JRPP No	2015SYE139
DA Number	DA-2015/431
Local Government Area	Willoughby City Council
Proposed Development	Redevelopment of Artarmon Public School
Street Address	5 Abbott Street, ARTARMON NSW 2064
Applicant/Owner	Mr Patrick Arthur Timmins / NSW Department of Education and Communities
Recommendation	Approval
Reports by	Ana Vissarion - Development Planner
Original Report date	14 April 2016
Supplementary report date	17 May 2016

SUPPLEMENTARY ASSESSMENT REPORT

Roof	Fence

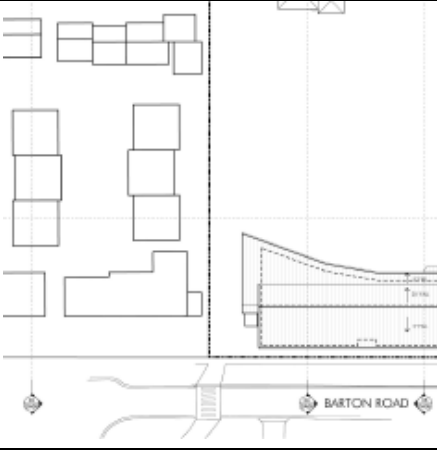
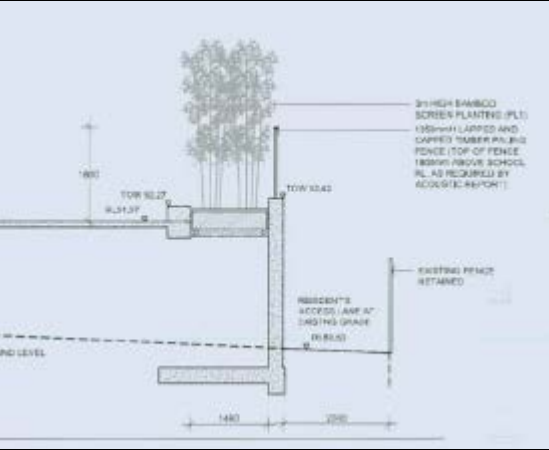
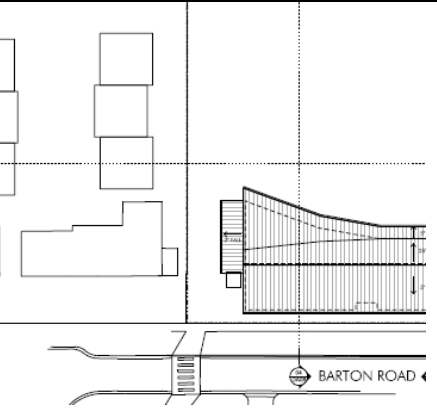
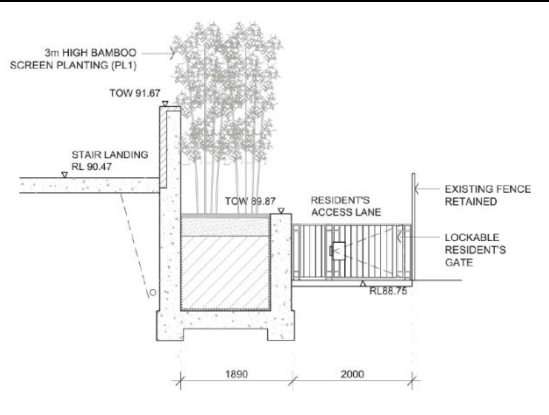
<p><i>Previous</i> Plan of the roof over external stairs & walkway. This roof consists of colorbond metal - as proposed at the JRPP meeting</p>	<p><i>Previous</i> Section through the retaining wall, made in the vicinity of Townhouse 2 – as proposed at the JRPP meeting</p>

<p><i>Amended</i> Plan of the roof over external stairs & walkway reduced in length at the northern end by 1m. This entire roof is now proposed to consist of translucent glass</p>	<p><i>Amended</i> Section through the amended retaining wall, now stepped back from the access lane, made in the vicinity of Townhouse 2</p>

- Lowering the height of the New Library and Homebase Building by 330mm in accordance with the recommended Schedule of conditions; and
- Metal roof over external stairs & walkway is reduced by 1 metre; and
- Metal roof over external stairs & walkway is replaced with a glass roof; and
- The retaining wall, the landscaping and the fence adjoining the Resident's Access Lane in the vicinity of Townhouse 2 at 3 Barton Road have been amended to minimise overshadowing impacts.

The report concludes that amending the design to cut back roof line 1 metre over the external access stairs & walkway as well as amending the design of the retaining/acoustic wall adjoining the resident's access lane will result in 2.5 hours of sunlight on the eastern living room window of Townhouse 2 at 3 Barton Road, from 11.30am to 2pm.

When the roof over the external access stairs & walkway is replaced by a 80% translucent glass, the eastern living room window of Townhouse 2 at 3 Barton Road receives additional light during the day, resulting in 3 hours of sunlight, from 11am to 2pm on 22 June.
